# WHITE PLAINS CITY SCHOOL DISTRICT

RENOVATIONS AT ROCHAMBEAU ALTERNATIVE HIGH SCHOOL SED Control Number: 66-22-00-01-0-015-020

### **CLARIFICATION TO PROJECT:**

M500.01

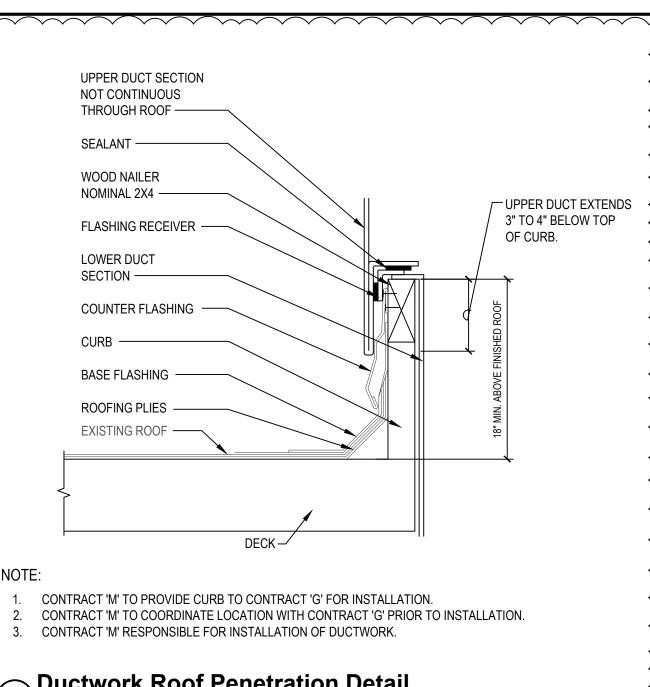
- 8. Remove M500.00 MECHANICAL DETAILS and replace with M500.01 MECHANICAL DETAILS. Details updated to reflect delineation of Contract 'M', 'G', and 'W' scope for roof work and penetrations.
